HIA Addendum

I Preamble

In July 2021 a Heritage Impact Assessment (HIA) report was completed as part of a Development Application (DA) submission package for a proposed Reptile & Amphibian Conservation Centre development at Taronga Zoo on behalf of the Taronga Conservation Society Australia (TCSA). Following further reviews by the TCSA, various (external and internal) architectural planning and design revisions have been made to the proposed schematic design by the architects (**dwp**). As a result of the external changes, some qualification has been required for the earlier heritage impact report.

ABOVE Building elevations (north above and south below) from **dwp** drawing AA2000 and BELOW before and after 3-D views from **dwp** drawing AA0003. (Both images courtesy of **dwp** architects)

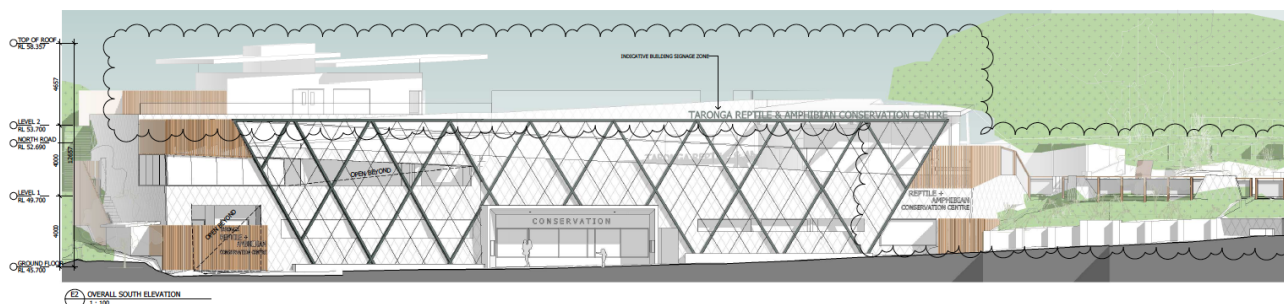
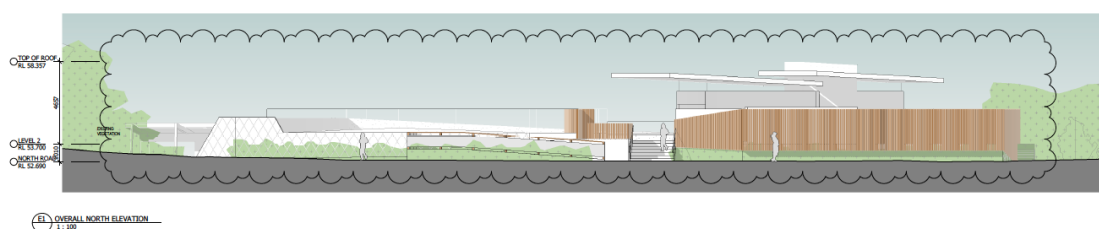
- * Revisions to the service access (no longer an internal dock area), waste store area and façade treatment at the SW corner;
- * Minor revision to the SE corner allowing views into holding area;
- * Perception of reduced bulk to west elevation through articulation of massing;
- * Additional identification sign to SE corner of building; and
- * Contraction of roof elements visible from southeast (lower level).

- * Remodelling of eastern end elevation;
- * Eastern access balustrading redesigned and now with various interpretive elements;
- * Perception of reduced bulk to eastern elevation; and
- * Eastern entry portal indicated in association with walling (entry sign) and (previous) road surface treatment.

- * Reduced to one upper level pavilion with remodelled/reduced roofs – more open area;
- * Perception of a 'flatter' elevation;
- * Deletion of translucent roofing;
- * Exit arrangement changed – ramp and steps;
- * Extent of road surface treatment reduced;
- * Increased landscape area to north;
- * Extent of building along the northern edge has decreased;
- * Extent of 'timber' façade treatment to NW increased; and
- * Reduced opportunities for visibility of the new building from the harbour.
